PRODUCT CHANGE NOTIFICATION (PCN)

A-MCUP-80005 MODULAR CABLE

CHANGE NOTIFICATION: PCN 20220425_A-MCUP-80005

SPECIFICATION	
ASSMANN WSW-No.	A-MCUP-80xxx/x
Drawing-No.	ASS 7407 CA rev04
Replace	Sheet

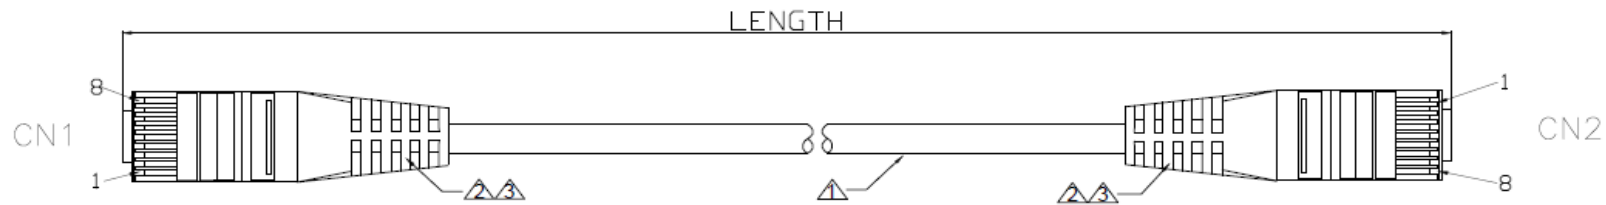
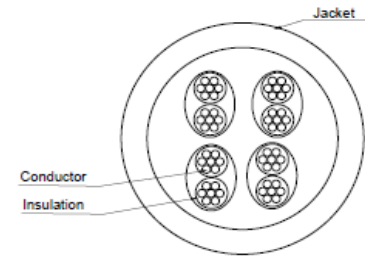
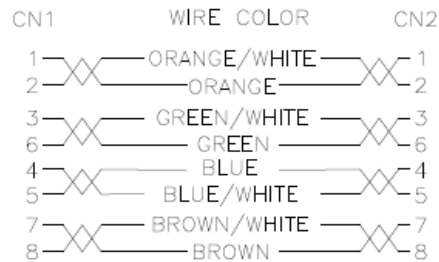
④	△	Molding PVC	2	Molding PVC 65P
④	△	RJ45 CONN	2	RJ45 8P8C, contacts 3u" gold-plated Un-shielded PC UL94V-2
④	△	CABLE	1	CAT 5E U/UTP(26AWGx1PR)*4+PVC Jacket OD:4.9±0.2mm
